**ADDENDUM NO. 3  
TO THE  
BIDDING REQUIREMENTS AND CONTRACT DOCUMENTS  
FOR THE  
CHANDLER 1.5 MILLION GALLON WATER TOWER PROJECT**

**ISSUED BY/ENGINEER:** Egis BLN USA, Inc.  
8320 Craig Street  
Indianapolis, Indiana 46250

**ISSUE DATE:** December 10<sup>th</sup>, 2025

**TANK SITE PLAN**

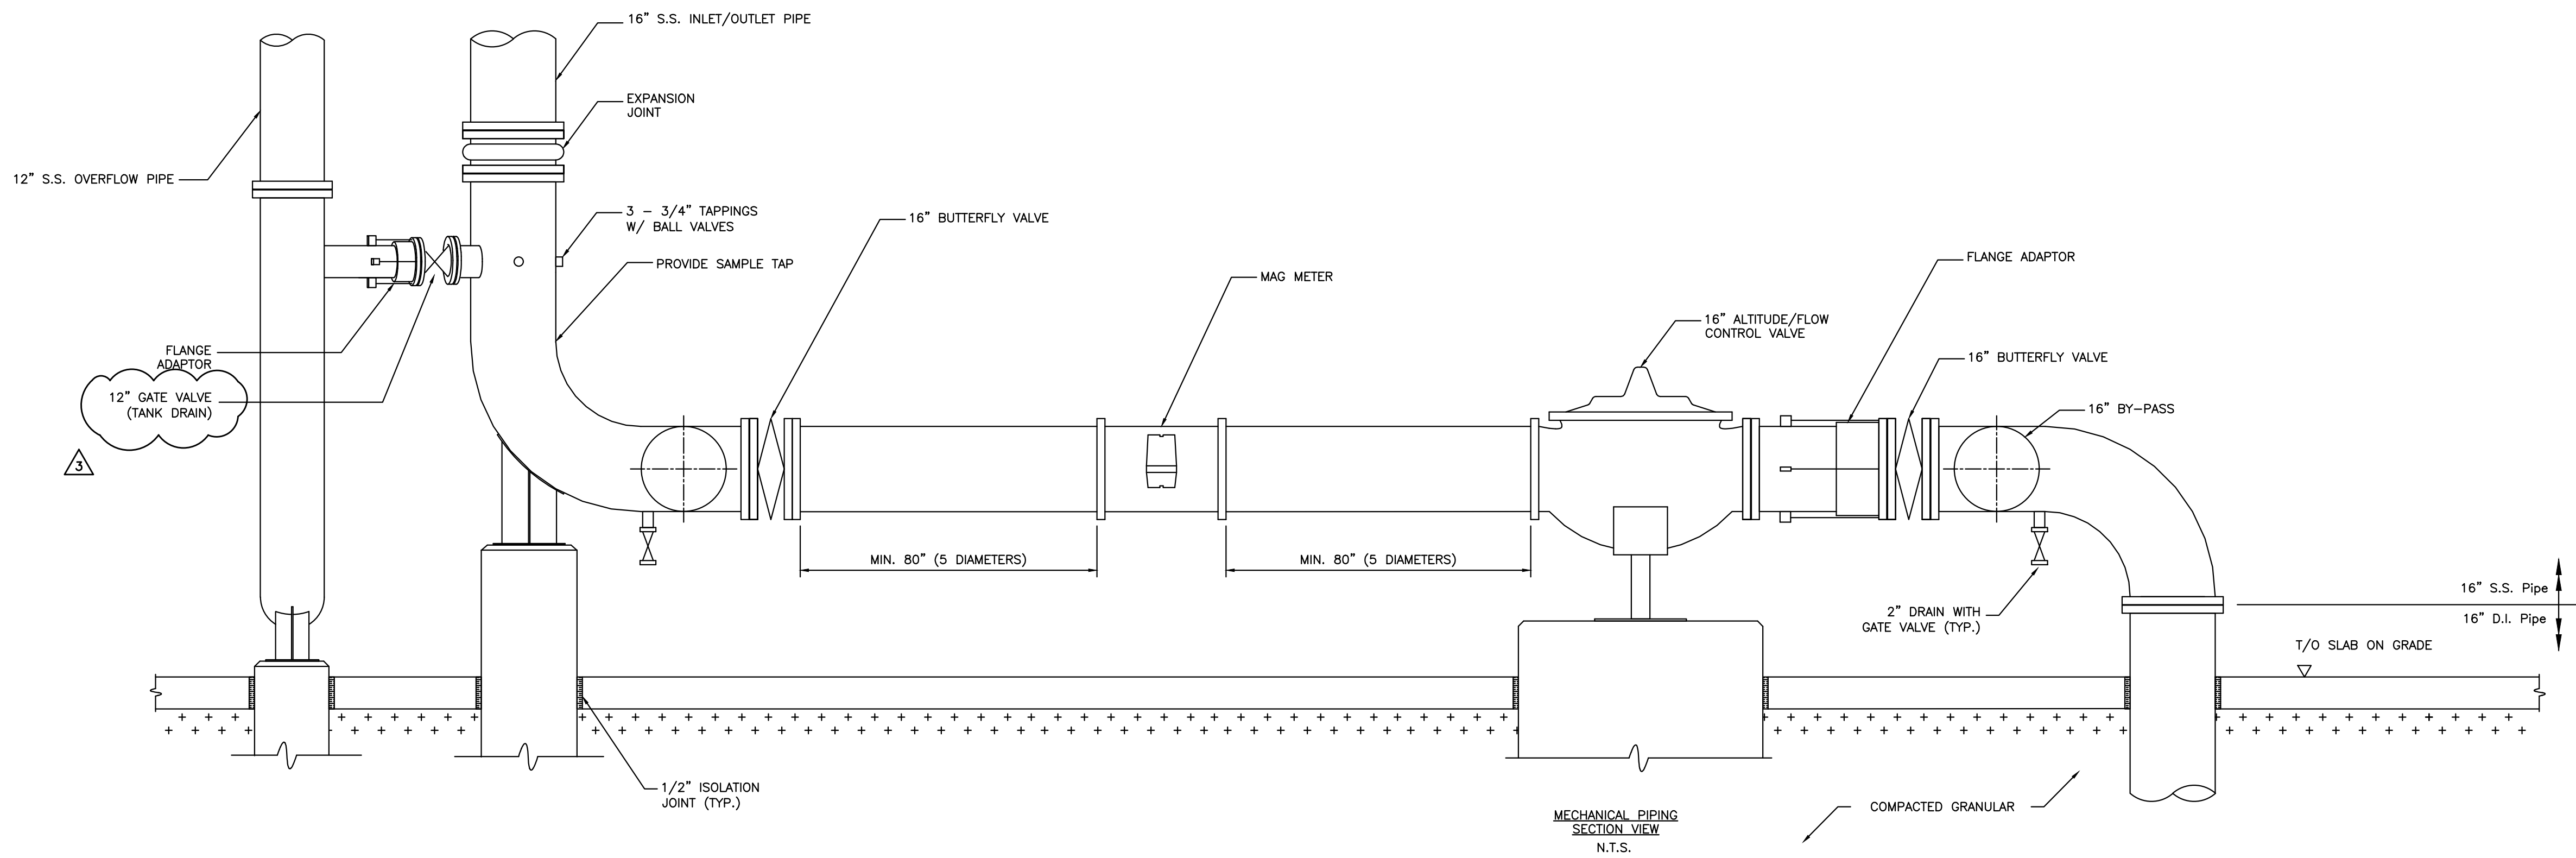
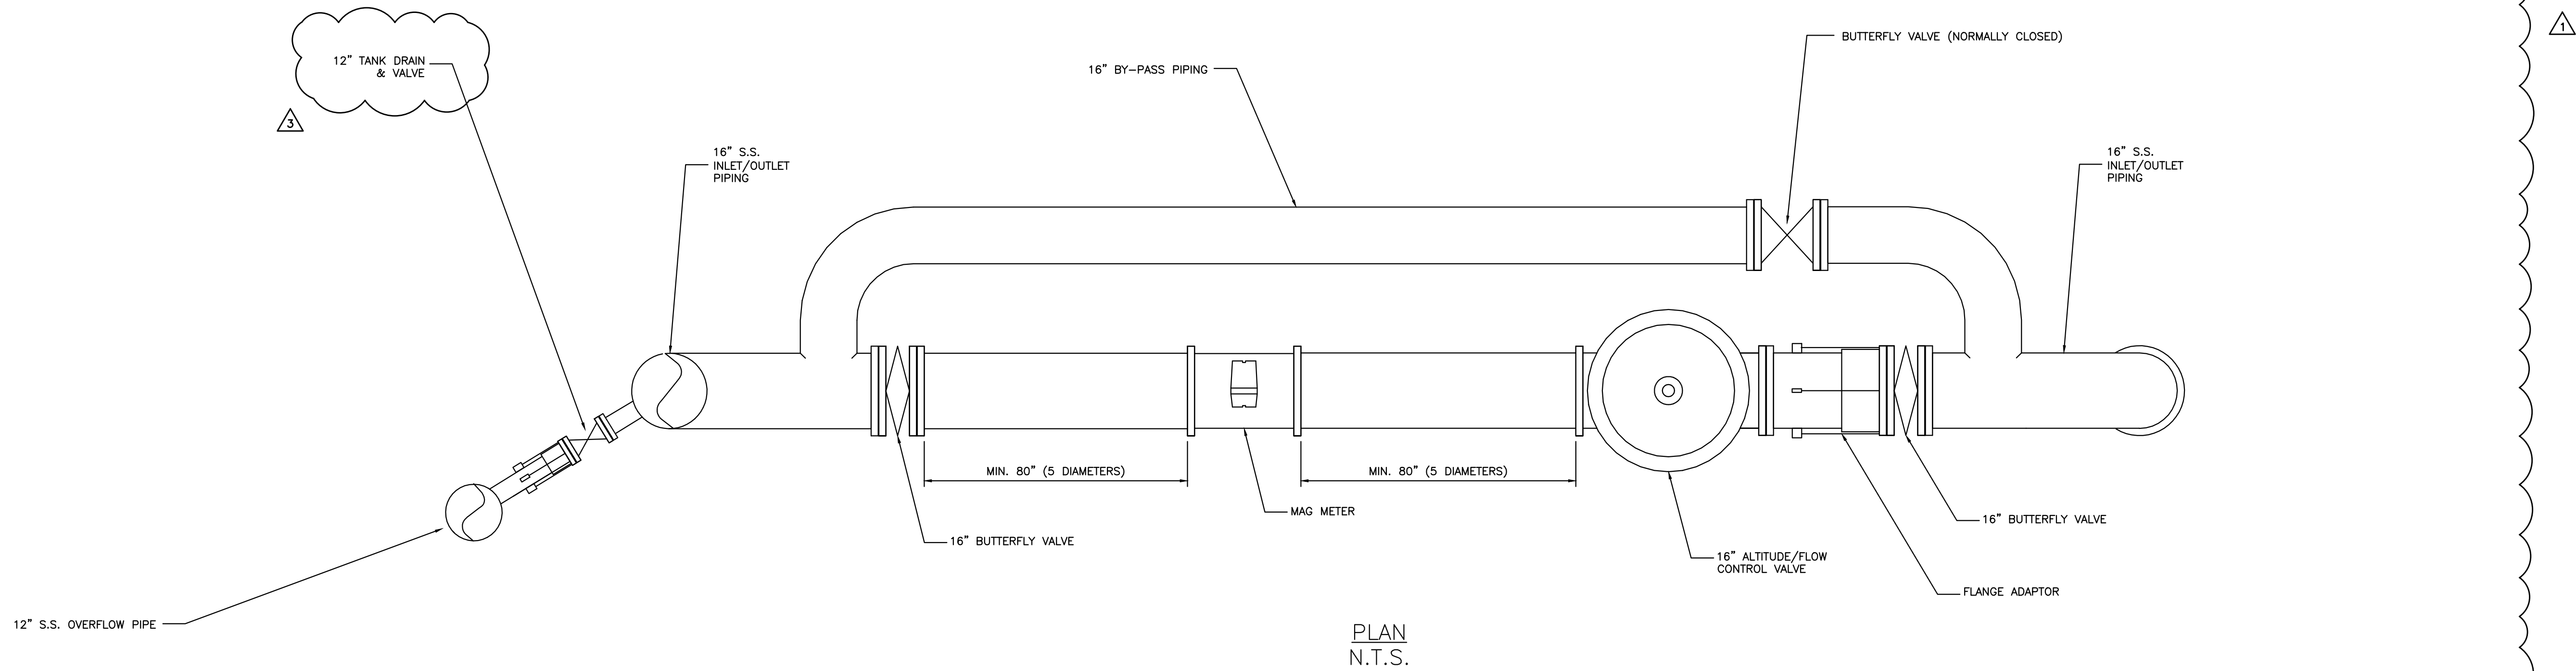
1. The proposed fence has been removed along the south side of the property. There are no changes to the quantity of fence as shown in Bid Form Attachment A.

**Q: Can you confirm the linear footage of the chain link fencing? The Bid Form says 650'. This appears to be only for the tank perimeter fencing, but there is also a separate section of ~210' for the section of fencing that separates the tank site from the properties to the south?**

R: The fence along the south side of the property had been removed from the total fencing in the Bid Form, but not from the plans. The plans have been updated to reflect this. The Bid Form quantity will remain the same. Please see Addendum Form No. 3 and the updated plans for more information.

## PARADISE & FRAME SITE DEMOLITION PLANS

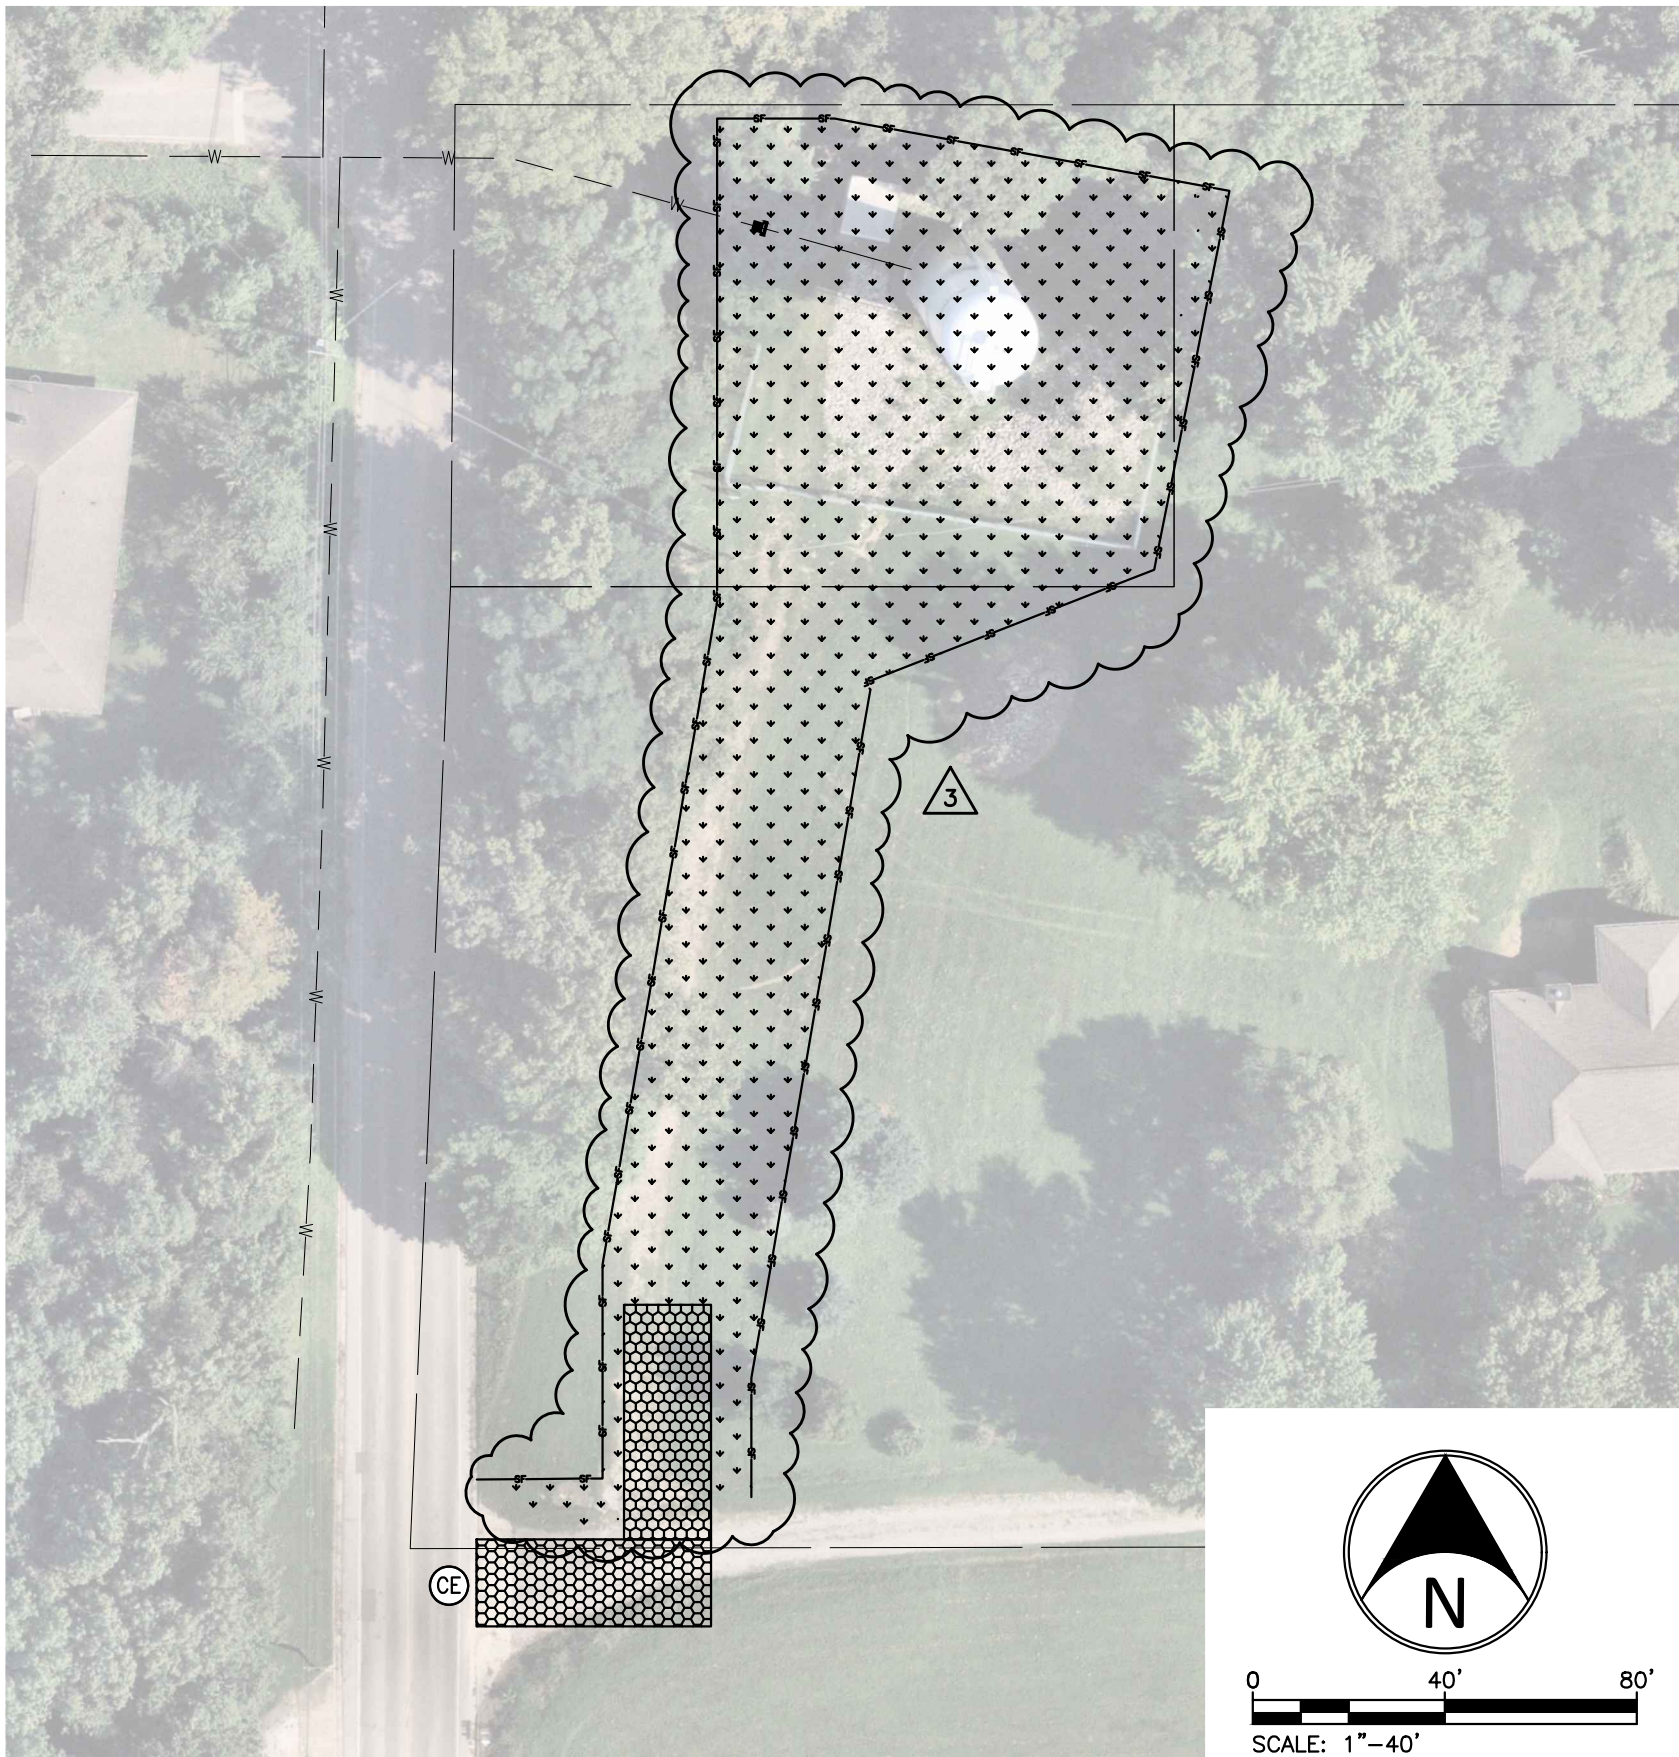
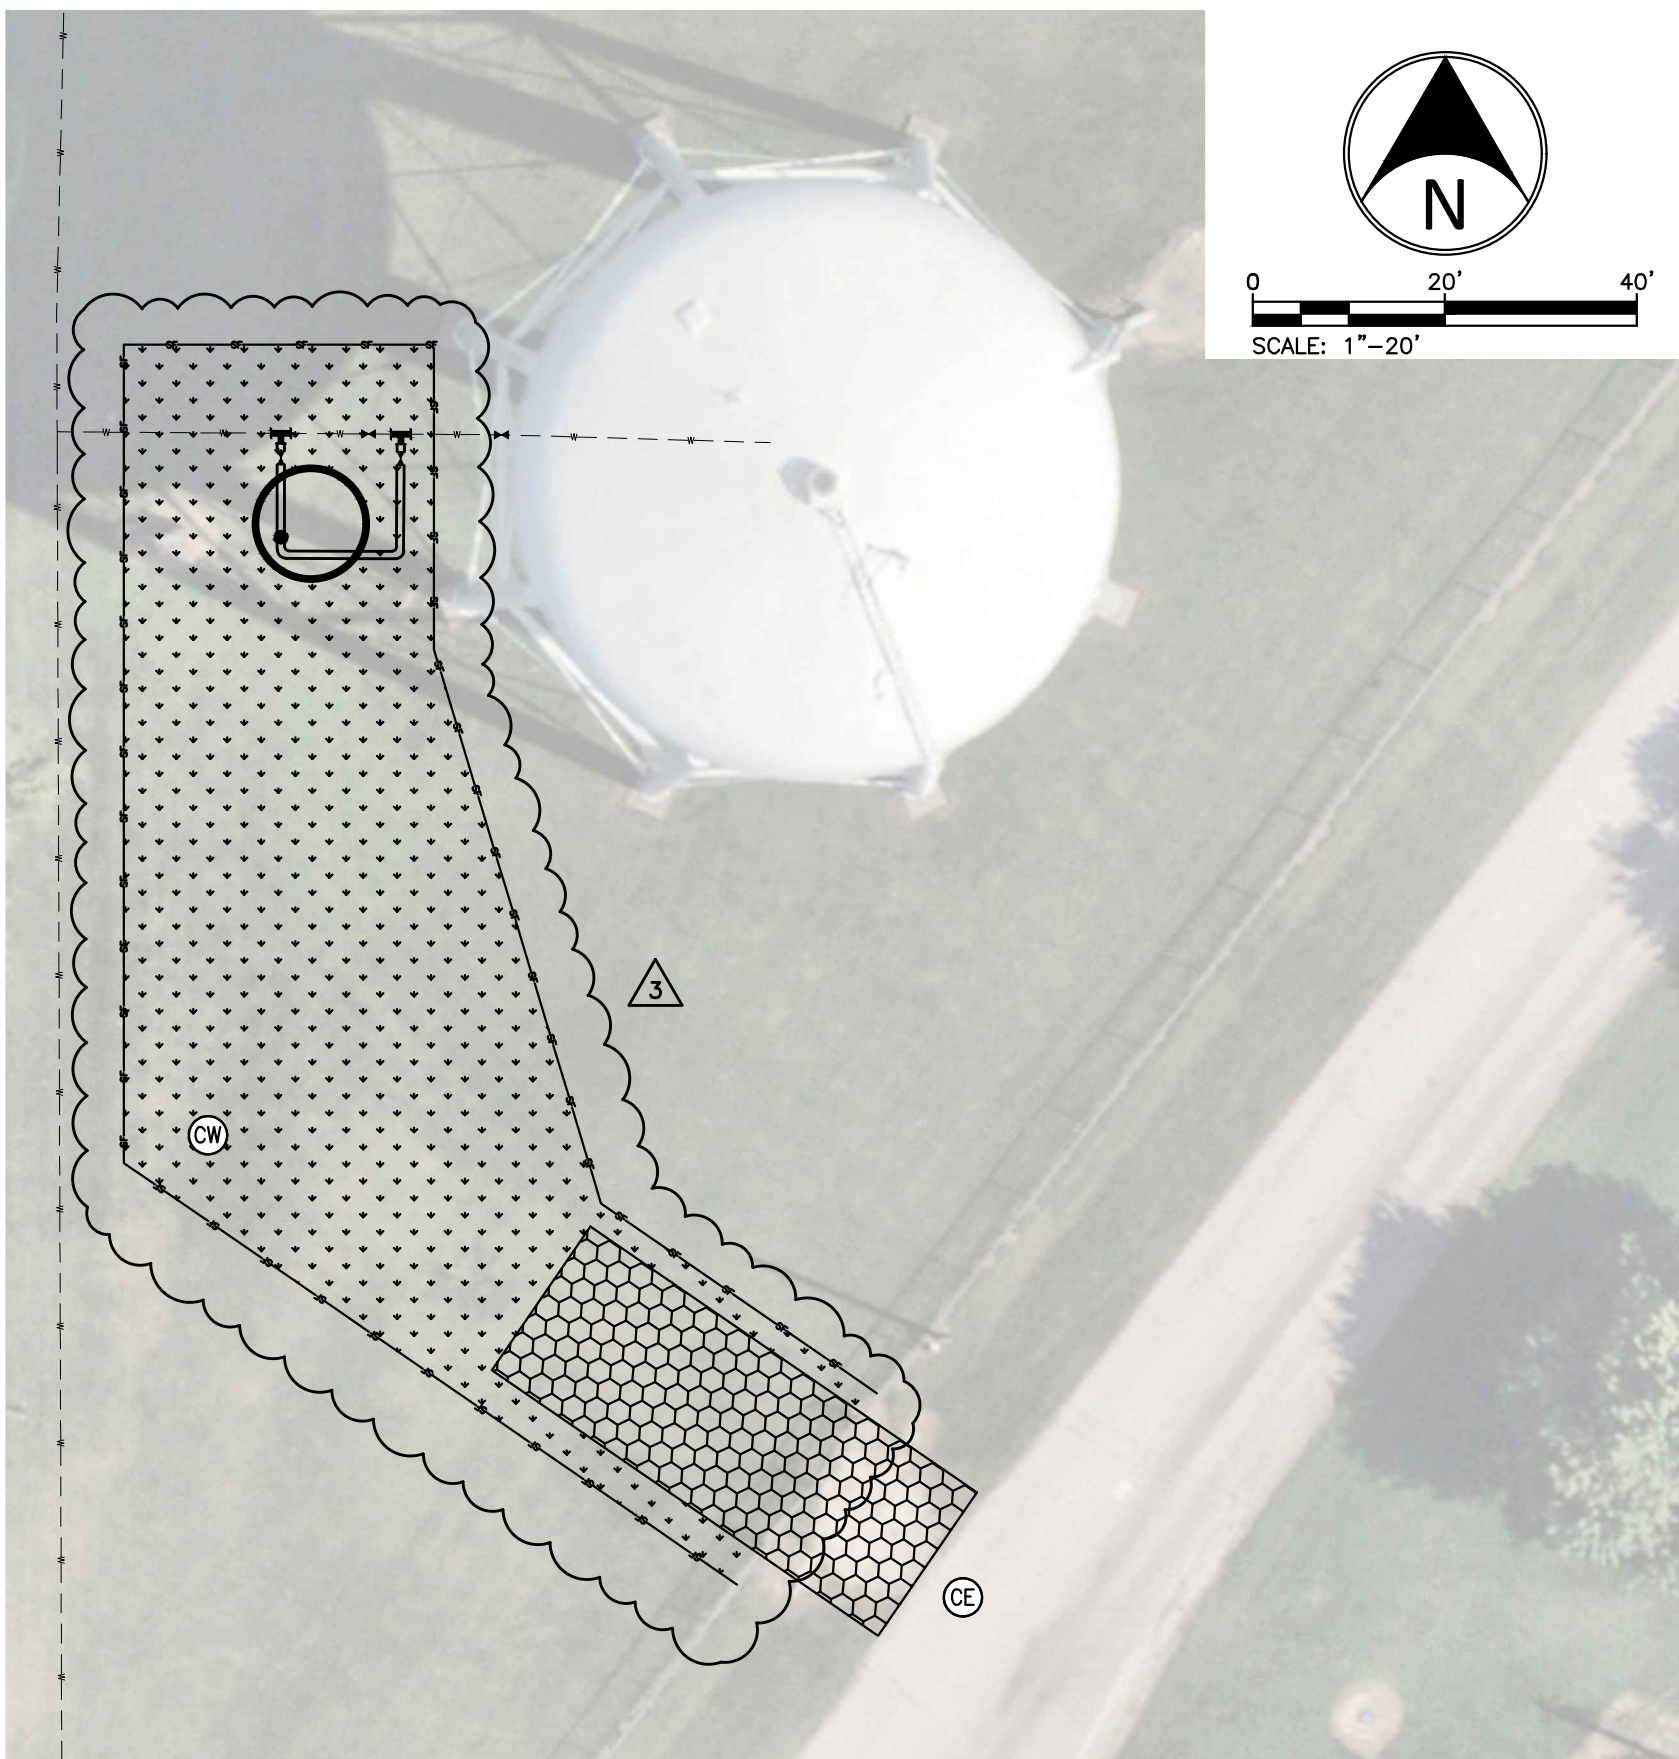
1. GIS property lines were added to the Frame Standpipe demolition plan to show approximate parcels.
2. Note was updated to indicate property lines taken from GIS.
